# Access Compliance Report

## Public Rights-of-Way

### (Curb Ramps)

Intersection ID: 49346	Main Street: BLUE_JUNCTION_RD	Cross Street: FIRESPIKE_RD	Location: SE
ADA ID: 97D6F33A73DD	Ramp Type: BlendTrans1	Initial Pass/Fail: Fail	Overall Compliance: No
Severity Score: 8.75			
Codes/Mitigation Info/Possible Solution		Field Measurements/Component Compliance

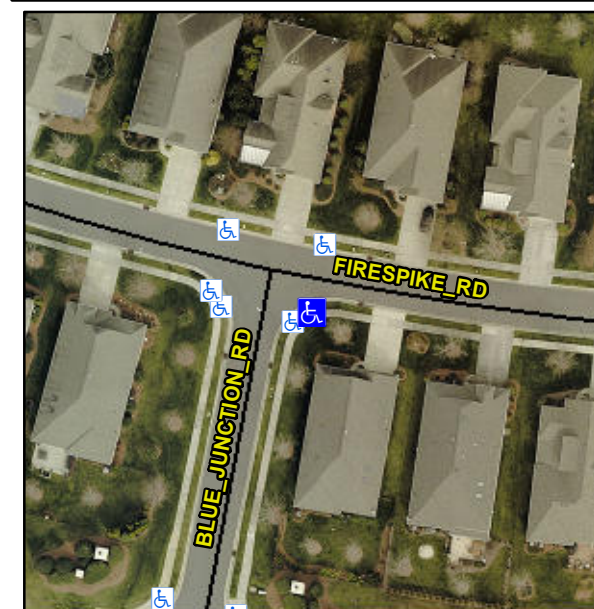
**Not Found, R304.5.1**

Compliance	Description	Data	Compliance	Description	Data
N/A	Ramp Length (in)	48.0	Yes	BlendTrans Slope (%)	2.9
No	Ramp Width (in)	46.5	Yes	BlendTrans XSlope (%)	1.9
N/A	Flare Type LT	N/A	N/A	Flare Type RT	N/A
N/A	Flare Slope LT (%)	N/A	N/A	Flare Slope RT (%)	N/A
N/A	Flare Traversable LT?	N/A	N/A	Flare Traversable RT?	N/A
N/A	Landing Length (in)	N/A	N/A	DWS Provided?	N/A
N/A	Landing Width (in)	N/A	N/A	DWS Contrast?	N/A
N/A	Landing Slope (%)	N/A	N/A	DWS Length (in)	N/A
N/A	Landing X Slope (%)	N/A	N/A	DWS Full Width?	N/A
N/A	Landing Curb? (Y/N)	N/A	N/A	DWS Offset (in)	N/A
N/A	Shared Landing?	N/A			
N/A	Gutter Ponding?	N/A	N/A	Gutter Slope (%)	N/A
N/A	Gutter Lip Ht (in)	N/A	N/A	Gutter X Slope (%)	N/A
N/A	Painted X Walk1?	No	N/A	Painted X Walk2?	N/A
	X Walk 1 Direction	To NE		X Walk 2 Direction	N/A
	X Walk 1 Width (in)	N/A		X Walk 2 Width (in)	N/A
	X Walk 1 Slope (%)	1.5		X Walk 2 Slope (%)	N/A
	X Walk 1 X Slope (%)	0.9		X Walk 2 X Slope (%)	N/A

N/A	Ramp inside XWalk1?	N/A	N/A	Ramp inside XWalk2?	N/A
	Road Slope (%)	0.9		Clear Space?	N/A
	Road X Slope (%)	1.5	N/A	Clear Space to XWalk (in)	N/A
N/A	Any Obstructions?	N/A	N/A	Storm Grate/Utility Hazard?	N/A
	Obstruction Type			Storm Grate/Utility Type	
		N/A			N/A
			Yes	Surface Condition? (G/P)	Good
			No	Curb Slope (%)	9.4

**Remove & Replace Curb Ramp With Two New Directional Ramps or Equivalent.**
